Application No.	Applicant(s)
Notice of Allowability	09/918.047	TAKEUCHI ET AL.
	Examiner	Art Unit
· · · ·	Charleton Lan	
	Cheukfan Lee	2622
The MAILING DATE of this communication appears on the cover sheet with the correspondence address All claims being allowable, PROSECUTION ON THE MERITS IS (OR REMAINS) CLOSED in this application. If not included herewith (or previously mailed), a Notice of Allowance (PTOL-85) or other appropriate communication will be mailed in due course. THIS NOTICE OF ALLOWABILITY IS NOT A GRANT OF PATENT RIGHTS. This application is subject to withdrawal from issue at the initiative of the Office or upon petition by the applicant. See 37 CFR 1.313 and MPEP 1308.

Application/Control Number: 09/918,047 Page 2

1. Claims 1-6 are pending. Claims 1 and 4 are independent.

FIG. 11 PRIOR ART

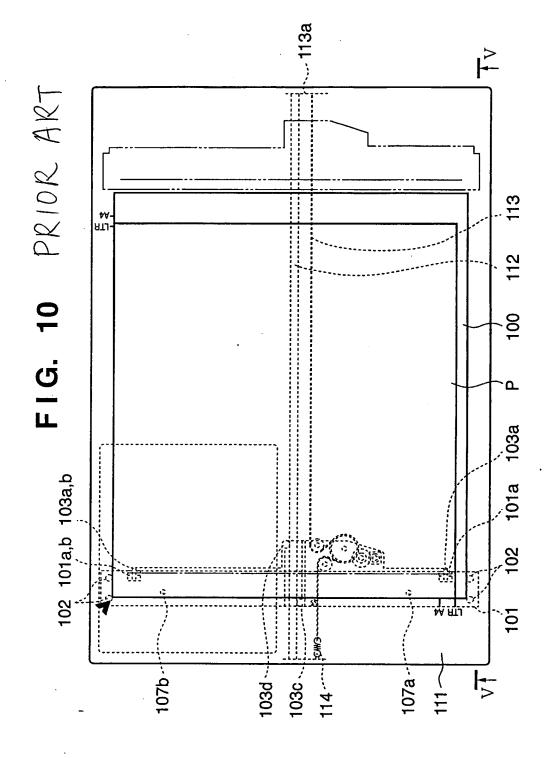
Label Figs. 10, 11, 12, 13, 14, and 15 with - PRIOR ART --.
